TOWN OF NEWBURGH PLANNING BOARD TECHNICAL REVIEW COMMENTS

CARLOS DOMINQUES II

2015-29

Re: Resubmission letter
Town Project No. 2015-29
Carlos Domingues II Subdivision
Domingues Road
SBL: 7-1-1.5
AR Zone
Job No. 15082-CDS

SUBDIVISION PLAN

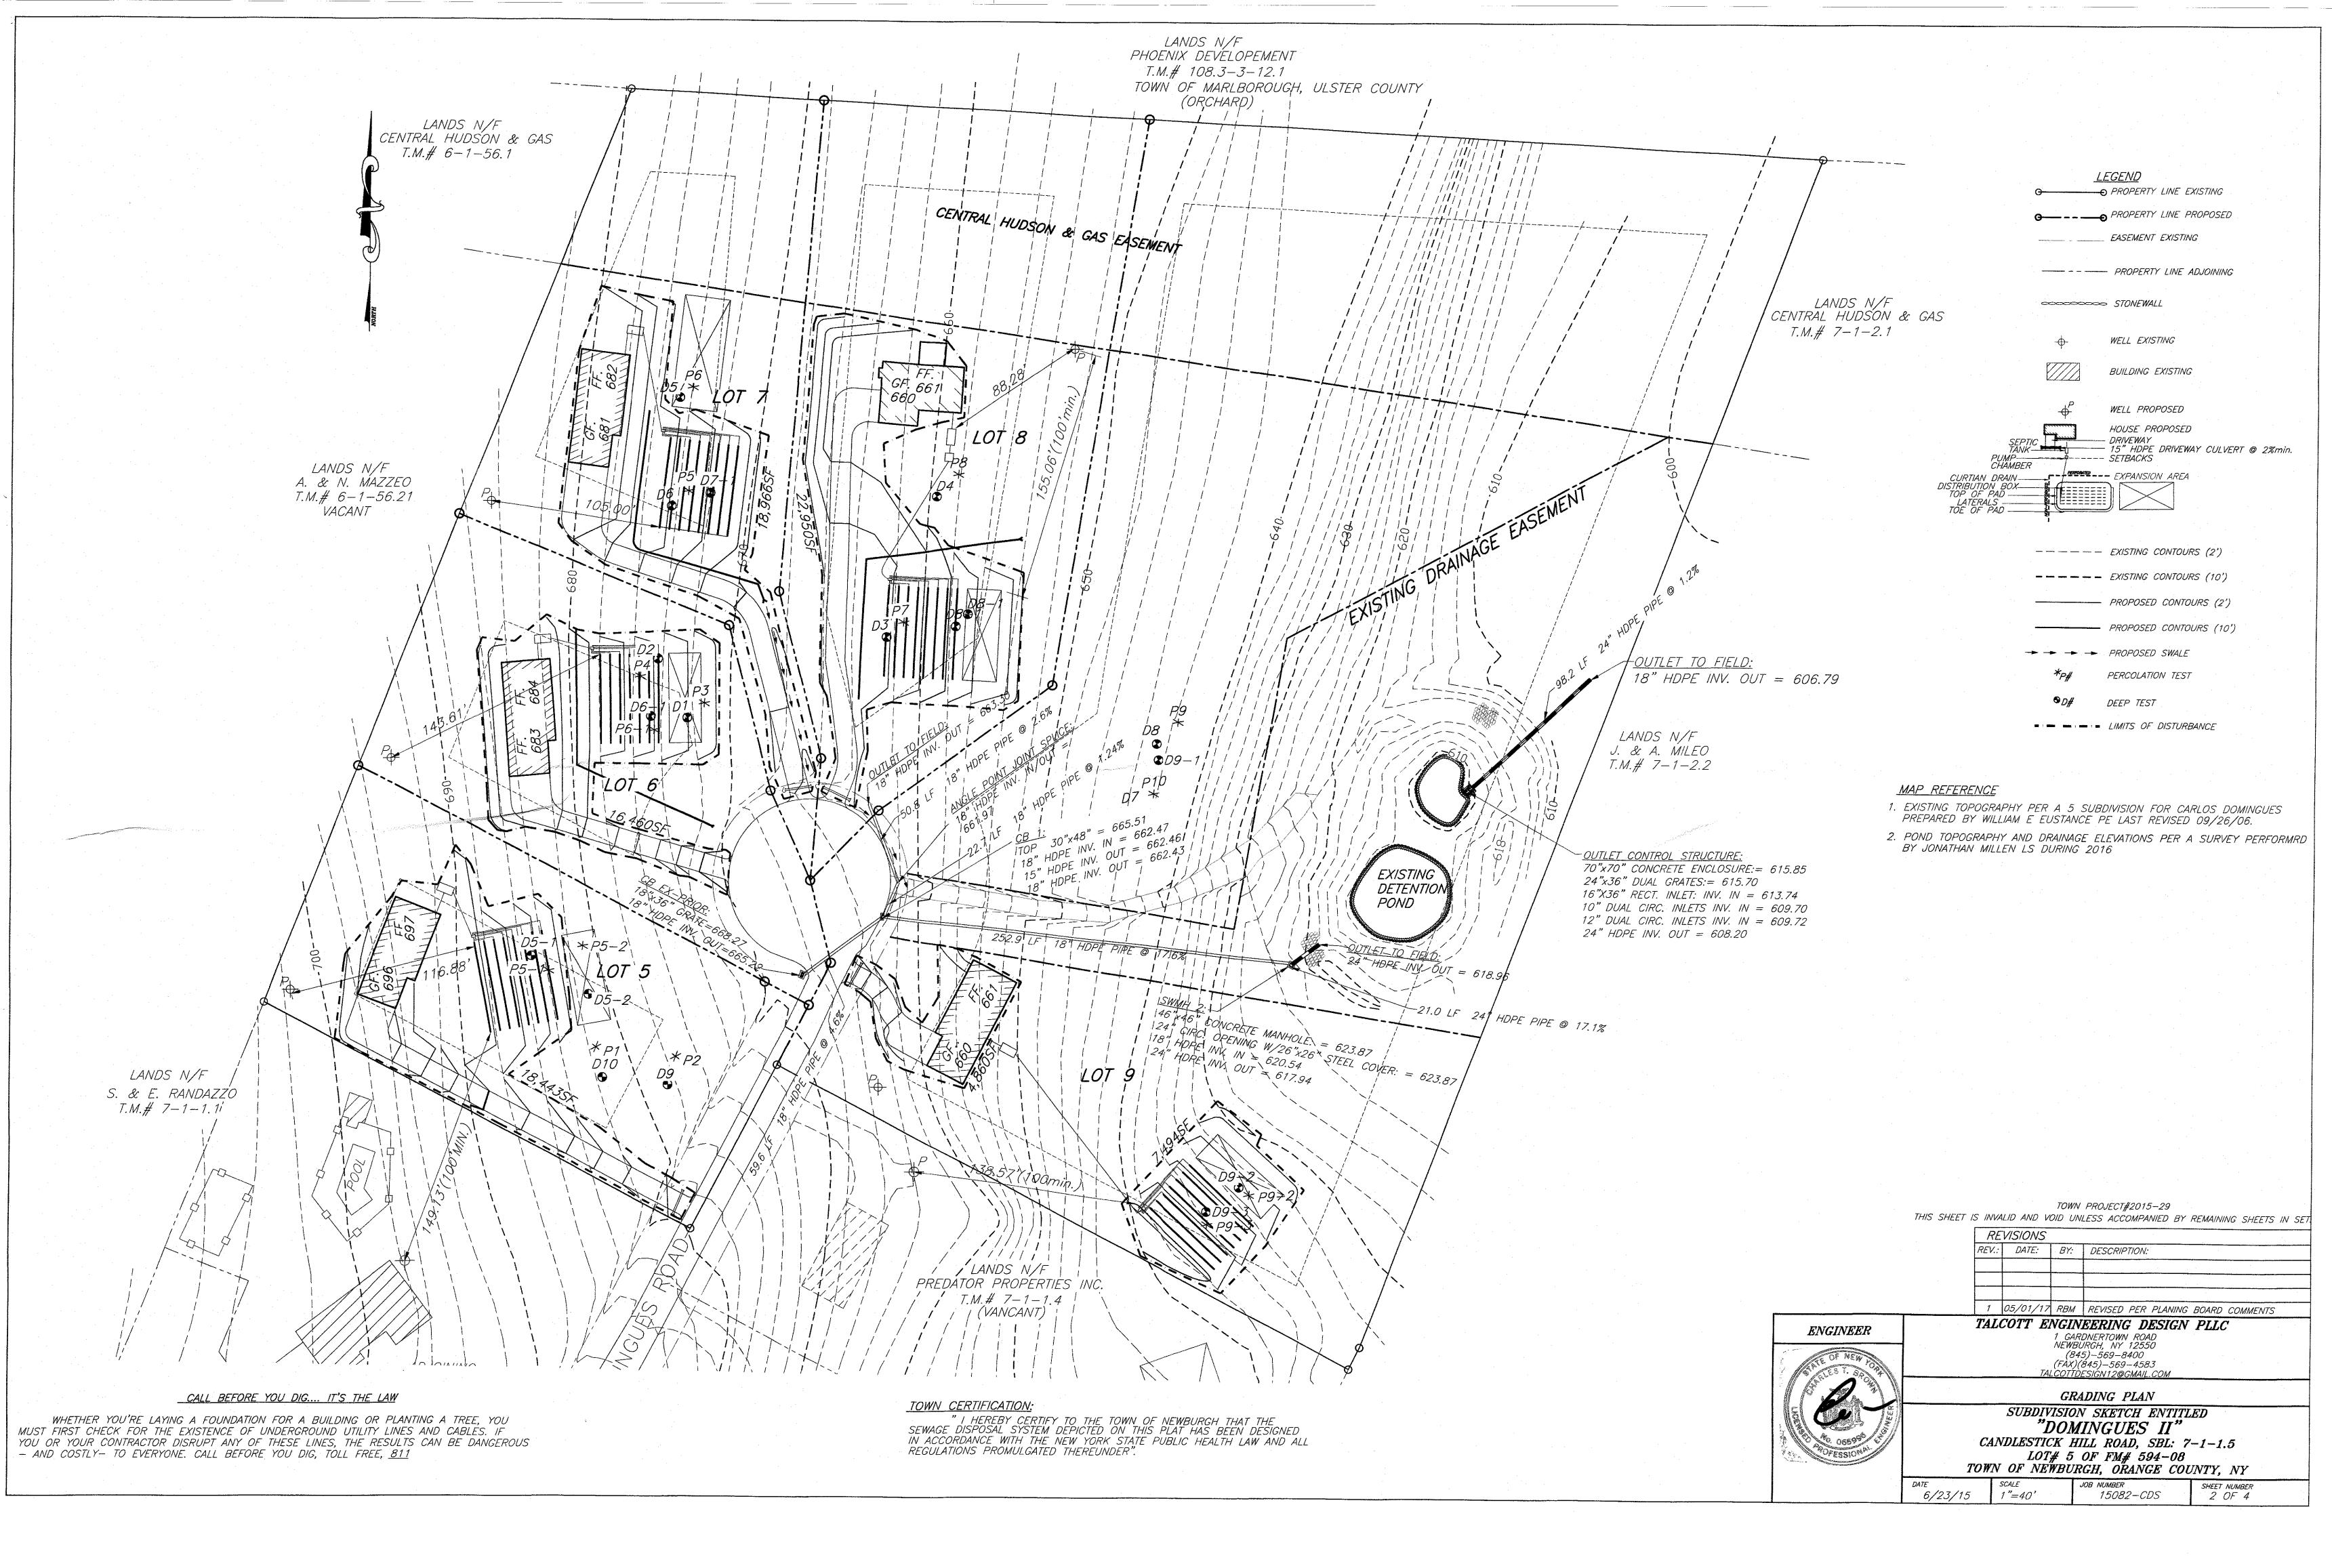
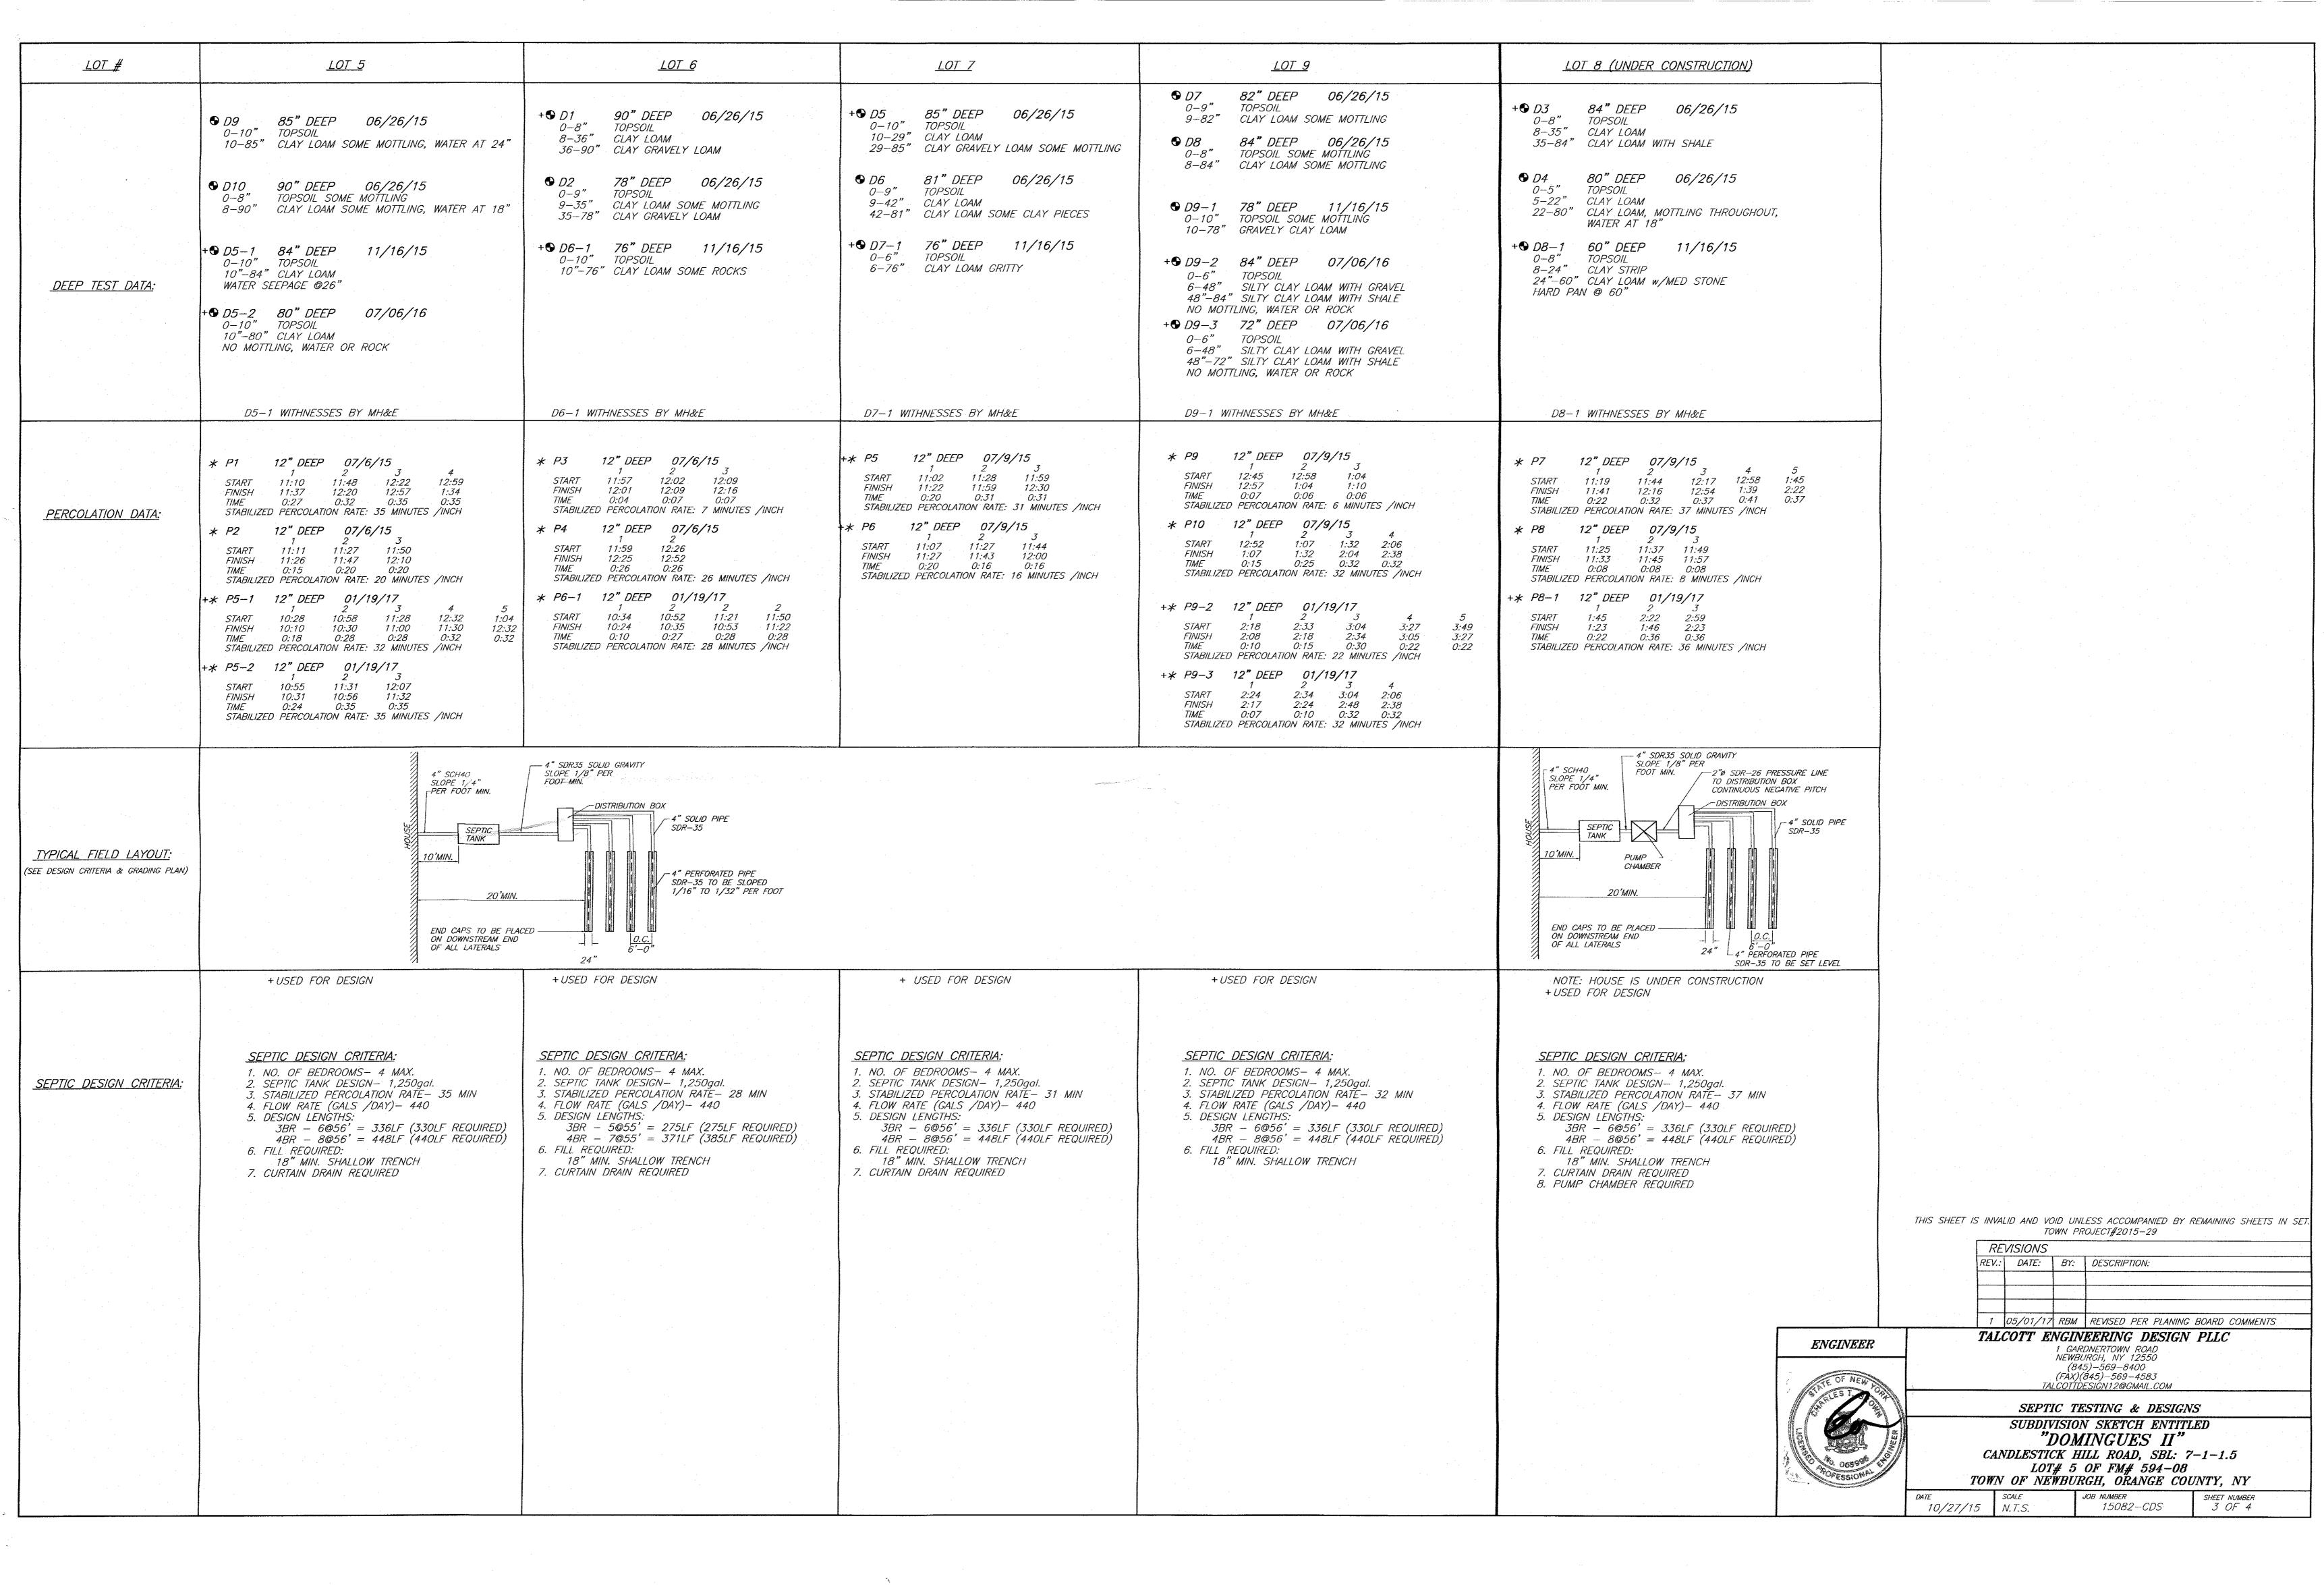
- 1. Copies of the private road access and maintenance agreement should be submitted to Mike Donnelly's office for review. Driveway on Lot #5 should be evaluated with regard to proximity to the common property line.

- Condition of the existing detention pond should be evaluated by the Applicant's representative
 to determine if any maintenance or repair work is required. Applicant's representative is
 requested to evaluate the increase in impervious surfaces proposed to be tributary to the
 detention pond facility with regard to the original design of the facility.

- 3. Due to proximity of the proposed residences to the bulk setback lines a note has been added to the plans requiring field surveys and stake outs of the structures and sanitary sewer disposal systems.

- 4. Size of driveway culverts should be called out on the plans.
- 5. A NYSDEC SPDES Stormwater Permit is required for the project. A soil erosion and sediment control plan should be developed consistent with the NYSDEC SPDES permit.

- 1) A field survey has been done, including As-Built of the existing retention pond. This pond was sized to accommodate this subdivision.
 - 2) Limits of disturbances are shown, with the calculated area shown under the bulk table.
 - 3) Drainage rims and inverts were surveyed and are on plans.
- 4) All existing and proposed wells and septic systems, within influence distances, are now shown on plans.
- 5) Additional site and soil testing was done, with deep tests witnessed by a representative of the Planning Board Engineer on November 16, 2015. Testing shows soils are adequate for systems as designed.

15" HDPE DRIVEWAY CULVERT @ 27min.
